Title: INDUSTRIAL TANK SUPPORT

Amendment Responsive to Office Action of September 3, 2004

Figure 1 - Replaced reference numeral 72 with reference numeral 66; replaced reference numeral 74 with reference numeral 68; replaced reference numeral 76 with reference numeral 70; and replaced reference numeral 78 with reference numeral 72.

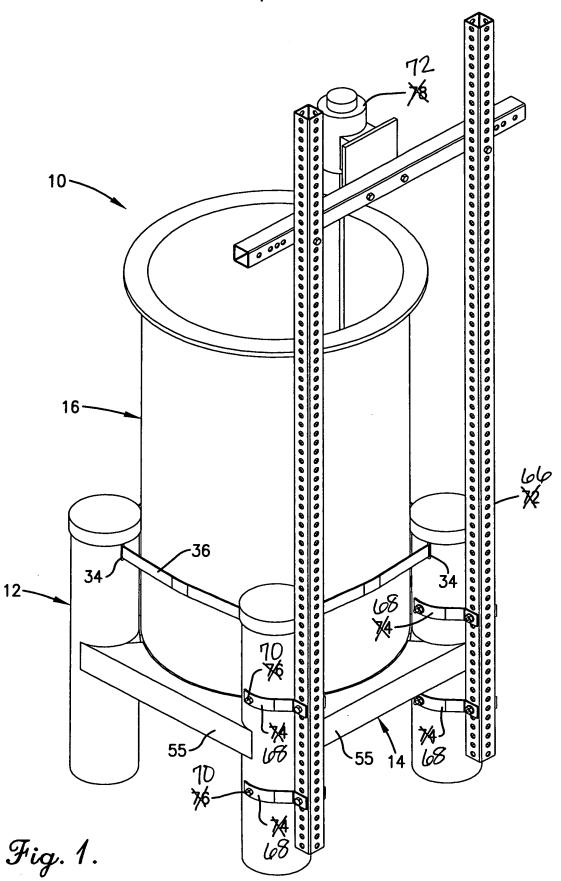
In the Office Action, the Examiner objected to the drawings as failing to comply with 37 C.F.R. § 1.84(p)(5) by not including in the specification the reference numerals 74, 76, and 78. Further, reference numerals 68 and 70 that were mentioned in the specification were not denoted on the drawings. Applicant has addressed the Examiner's objections by removing reference numerals 74, 76, and 78 from the drawings and adding reference numerals 66, 68, and 70 to Figure 1. Additionally, Applicant notes that reference numeral 24, which is discussed at page 4, lines 23 and 30 and page 15, line 15, was not denoted in Figure 4. Reference numeral 24 is to the sidewall of each leg, as discussed in the specification at page 4, line 23. Applicant has amended Figure 4 to now denote reference numeral 24. Annotated Marked-Up Sheets illustrating the drawings changes in red accompany this Amendment. Should the Applicant's amendments be acceptable to the Examiner, Applicant has also attached Replacement Sheets that are formalized.
